## Notice of Administrative Decision

**RE:** Permit Number: 23-00331  
Project Name: Wissmer - Critical Area Buffer Variance Type II Buffer Reduction  
Type of Application: CABR

## Administrative Staff Report

**Project Name:** Wissmer - Critical Area Buffer Reduction (CABR)  
**Type of Application:** CABR Type II  
**Permit Number:** 23-00331

**6. Site Design**

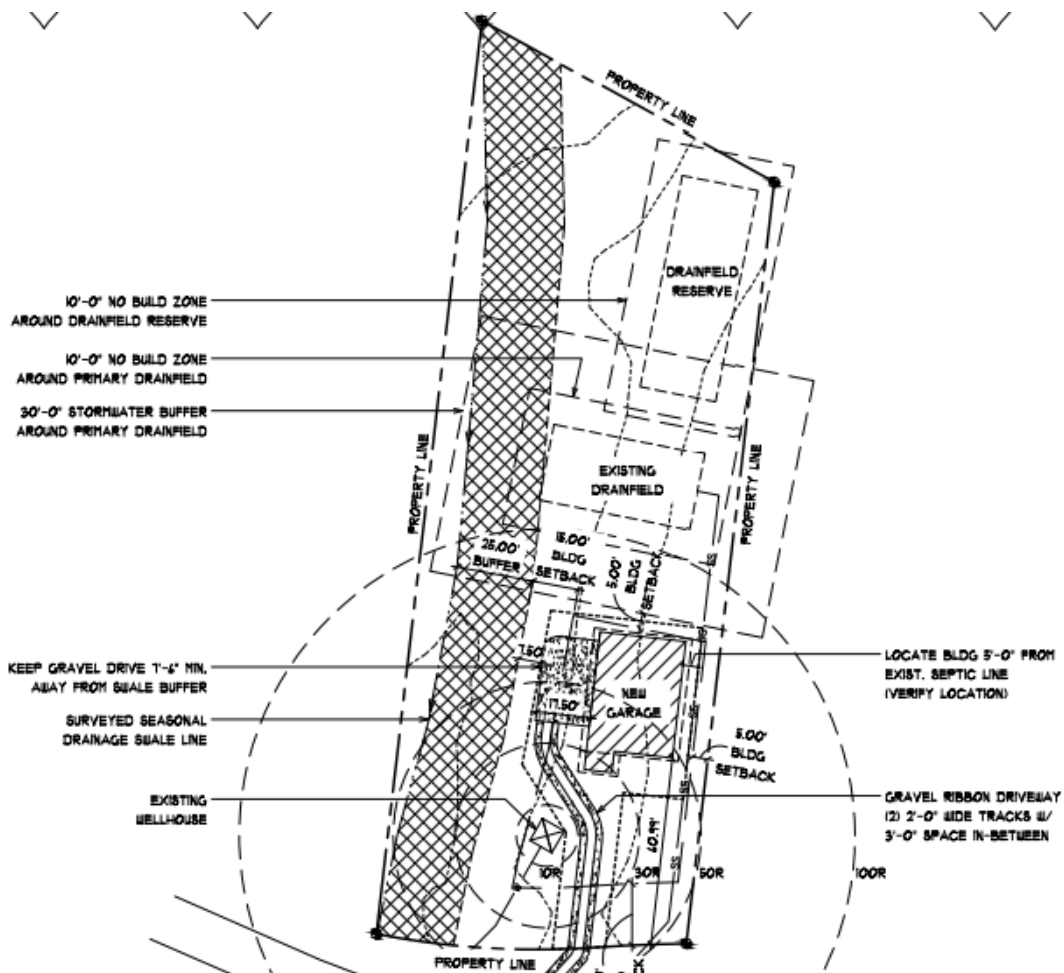
The image below shows the proposed footprint of the detached garage, the proposed driveway, associated parking, onsite septic (OSS), including drainfields and a drinking well for the benefit of the single-family residence south of Wye Lake Blvd. S.W. The site plan also shows the location of the onsite stream and those buffers.

The detached garage will require a 50% reduction to the stream buffer width and a 7.5-foot building setback totaling 32.5 feet from the edge of the buffer. A habitat management plan and mitigation report (HMP) were prepared that includes installation of 65 native plants and recommends the use of a minimum of 5 varied species installed between the stream and the new development.

Staff Comment: The site is constrained with critical areas and those buffers running along the west side of the site and the septic drain fields existing at the northern portion of the site. There is only one feasible area to build the detached garage. applicant has addressed avoidance and minimization in the proper sequencing. As the applicant comment states in the preceding section, the scope of this proposal is indicative to surrounding properties mentioned and found in exhibit titled Wissmer Report-Type II Buffer Reduction and Narrative (HMP), dated December 3, 2022, conducted by Christy Christenson, Biologist for C3 Habitat.

Staff Comment: The submitted HMP characterizes the stream buffer functions as well as areas outside of the buffer. The report states that avoidance is not possible and discusses minimization and mitigation. Plantings will be installed along the east side of the stream and west of the gravel driveway, enhancing the stream buffer. The proposed mitigation

is enhancing the resultant buffer where it is mostly dominated by Himalayan blackberry currently. The restoration area requirement is 1,815-ft<sup>2</sup> and will be exceeded by planting approximately 3,188-ft<sup>2</sup> with a diverse native plant community. The proposal minimizes impacts by placing the accessory structure in an area furthest from the stream while still maintaining the 5-foot side setback requirement as well as setbacks from the septic line at the east, drainfields to the north, and existing well at the south.

8. Vegetation planting shall occur as specified in the approved Habitat Management planting plan (conducted by C3, dated October 19, 2023), produced in support of this

permit. Planting of native vegetation shall occur within the first dormant season once the permitted project has been constructed and approved. When planting is complete, the applicant must contact Development Service and Engineering Staff at (360)337-5777 for a site inspection and as-built approval. Monitoring and maintenance of the planted area shall be conducted for three years after DCD staff approves planting. Monitoring includes live and dead vegetation counts and records of all maintenance activities. Maintenance activities can be defined as, but are not limited to, removal practices on invasive or nuisance vegetation and watering schedules. Monitoring information shall be summarized in a letter with photographs depicting conditions of the vegetation and overall site. Monitoring reports are due to Kitsap County Department of Community Development Services and Engineering Division by December 31 of each monitoring year. If more than 20 percent of the plantings do not survive within any of the monitoring years, the problem areas shall be replanted, and provided with better maintenance practices to ensure higher plant survival.
